MODERNIZATION AT CURRAN MIDDLE SCHOOL FOR:

BAKERSFIELD CITY SCHOOL DISTRICT

INTERIOR ELEVATIONS BUILDINGS F & G

A-2310

E1 BOY'S TOILET F-104
1/4"=1'-0"

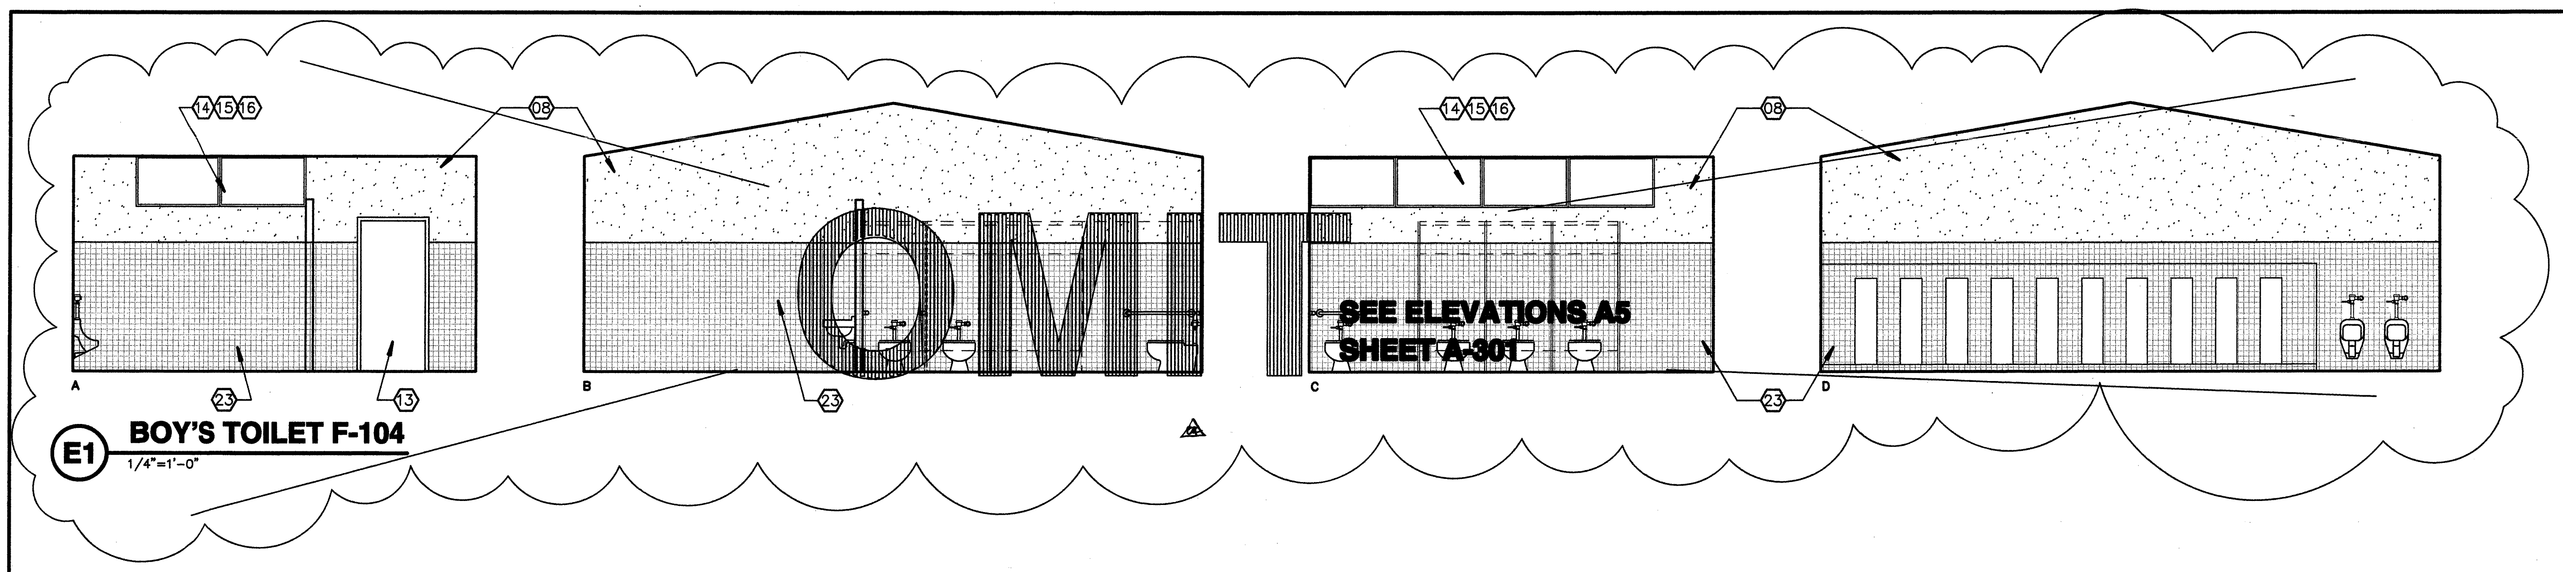
Item No. 18: Refer to Sheet A-2310
Omit Interior Elevations E1. Interior Elevation "DI" Elevation "D" Keynote # 24 incorrect, revise to read."04." Revise Keynote #02 to read. "Remove and replace existing counter top with corian countertop with 6" splash (unless noted otherwise) calk to wall typical." Revise Keynote 03 to read. "Replace existing sink cabinet with ADA compliant sink cabinet, typical all sink cabinets." Revise Keynote #4 to read. "Existing cabinet to remain, remove and replace all doors, drawer fronts, & face plates. Finish per specifications." Revise Keynote #18 to read. "Remove existing trough sink, provide install corian counter with 6" splash & accessible sink per plumbing plans. See addendum drawing ADD-007 for further requirements." Delete Keynote #19
